ELECTRICAL SERVICES LAYOUT
TOWN HALL
LOWER GROUND FLOOR

HORNSEY TOWN HALL

Responses to LIP Comments 23/05/2022

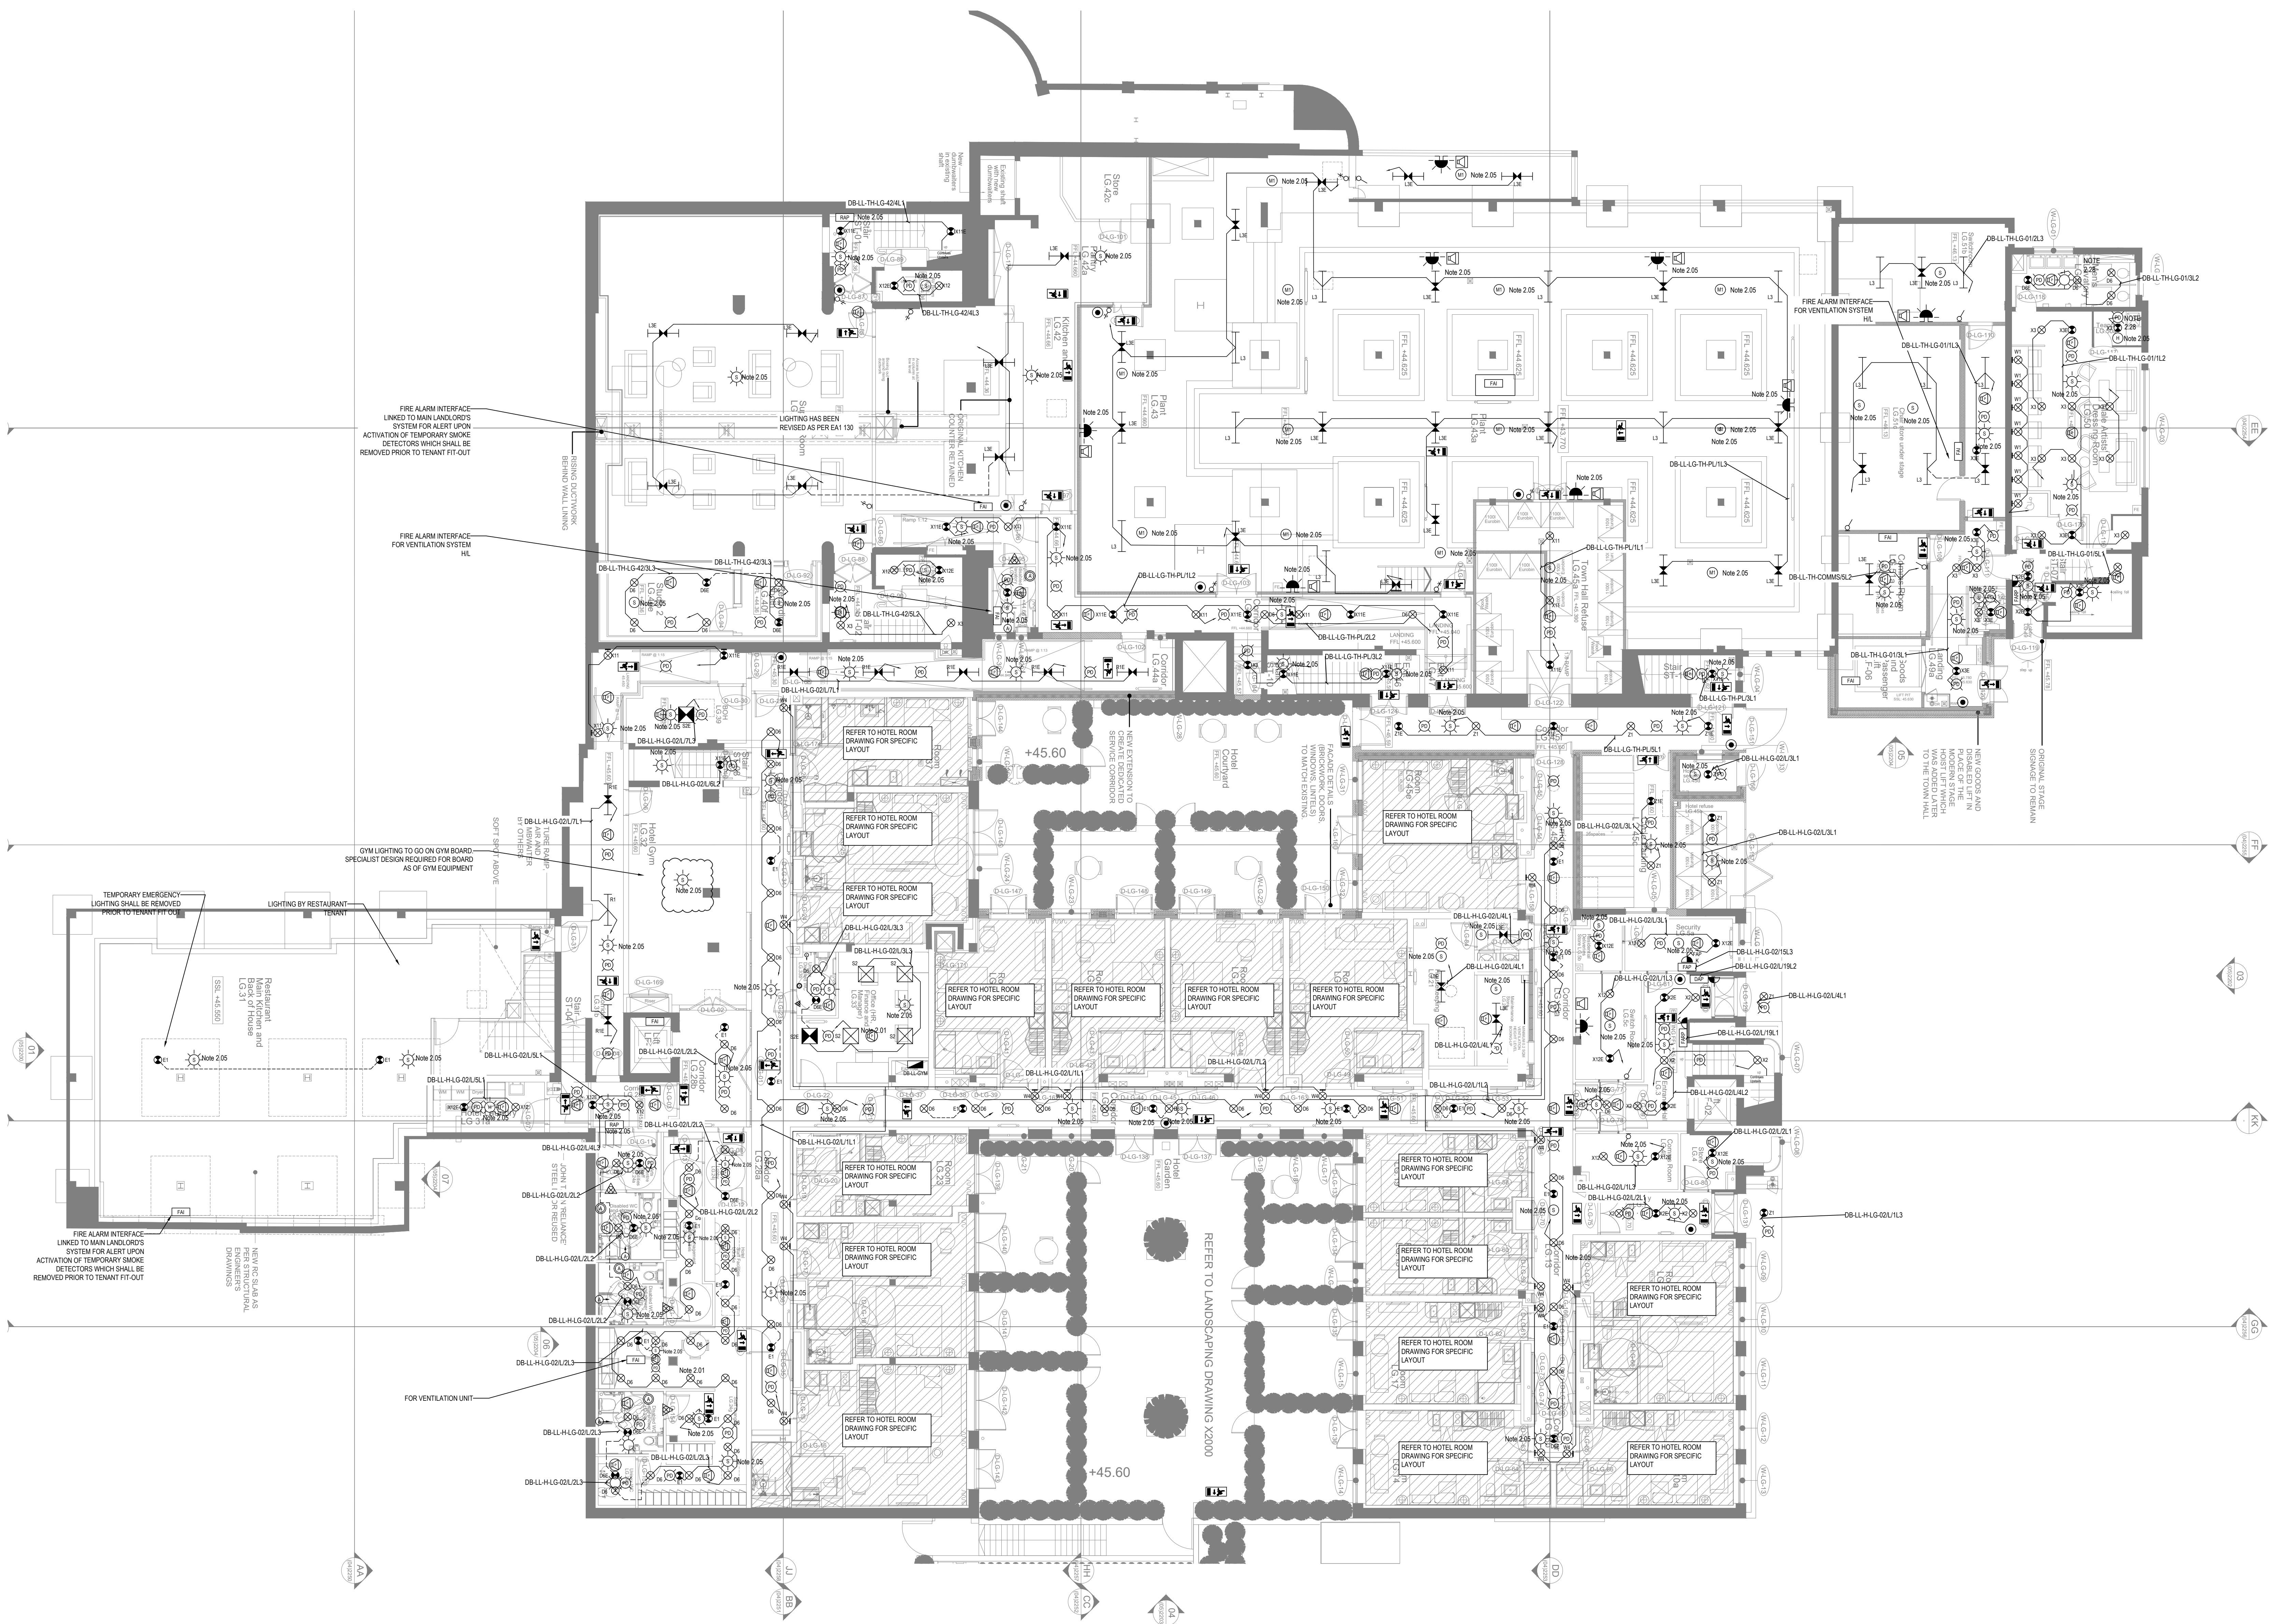
1. It is assumed that all services are coordinated with architectural and structural layouts >Noted
2. It is assumed that this drawing complies with the EPG and any deviations are highlighted. >Noted

3. Layout does not incorporate the instruction for the Laundry room - initial Architectural & MEP RCP and detail notes are to be added to capture this change. - The luminaires schedule has been designed to reflect this change

4. Luminaires X1 and X4 do not appear on Luminaires schedule : The Luminaires schedule has been designed to reflect this change
5. Please provide lux level calculations : To be provided

6. Confirm DO lighting can be accommodated within ceiling void : Yes
7. Supper room lighting layout does not appear to incorporate detail instruction : Initial architectural RCP and detail notes are to be added to capture this change

8. Please provide dimensions setting out for each component : To be incorporated on architectural RCPs
9. Please include lighting control wiring diagrams : Please refer to manufacturer data sheets

10. Show where exposed conduit is used to light switches : To be shown on an off drawing
11. Confirm installation proposal where fixing to steel purlins : Contractor to confirm
